Project	<b>IEEE 802.16 Broadband Wireless Access Working Group</b> < <a href="http://ieee802.org/16">http://ieee802.org/16</a> >	
Title	<b>Renaming of handover and paging SAP primitives in section 14.5.9.3</b>	
Date Submitted	<b>2006-01-09</b>	
Source(s)	Ronald Mao Huawei Technologies Co., Ltd. 10180 Telesis Ct #365 San Diego, CA 92121	Voice: 001-858-882-0335 Fax: 001-858-882-0350 <a href="mailto:rmao@huawei.com">rmao@huawei.com</a>
Re:	Contribution on IEEE 802.16-2004/IEEE802.16g	
Abstract	This contribution proposes to update the primitive names in sections 14.5.9.3 of 16g r2.	
Purpose	Adoption	
Notice	This document has been prepared to assist IEEE 802.16. It is offered as a basis for discussion and is not binding on the contributing individual(s) or organization(s). The material in this document is subject to change in form and content after further study. The contributor(s) reserve(s) the right to add, amend or withdraw material contained herein.

The purpose of this contribution is to update M-SAP and C-SAP primitive names based on universal naming schema.

Figure 324— Location Update Primitives

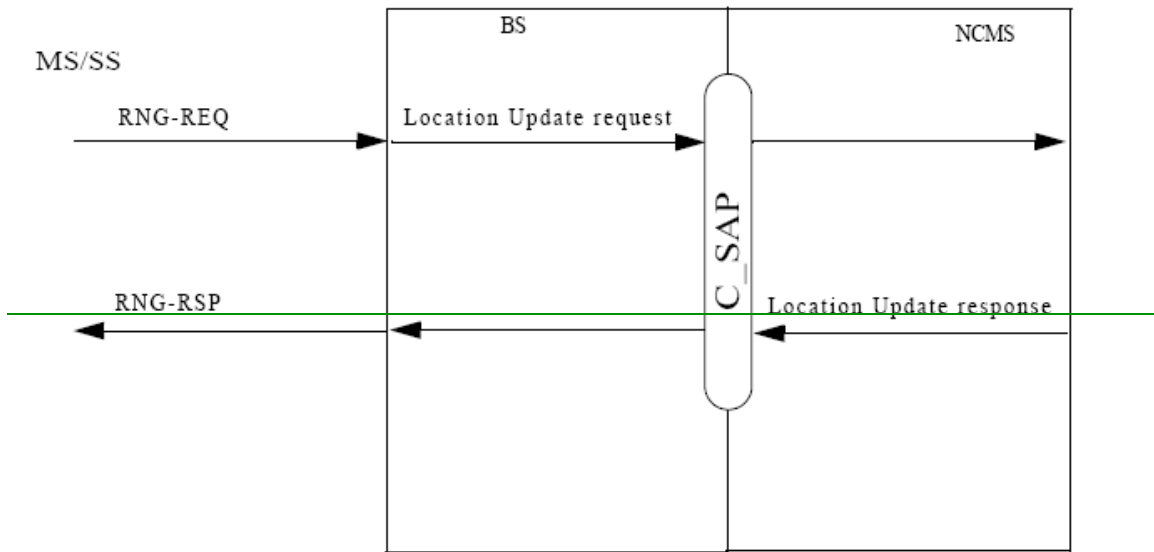
Figure [1324](#) shows service primitives for Location Update between a BS and an NCMS.

14.5.9.3.2.1 ~~Location Update request~~ C-PG-REQ

#### 14.5.9.3.2.2 C-CM-RSP Location Update response
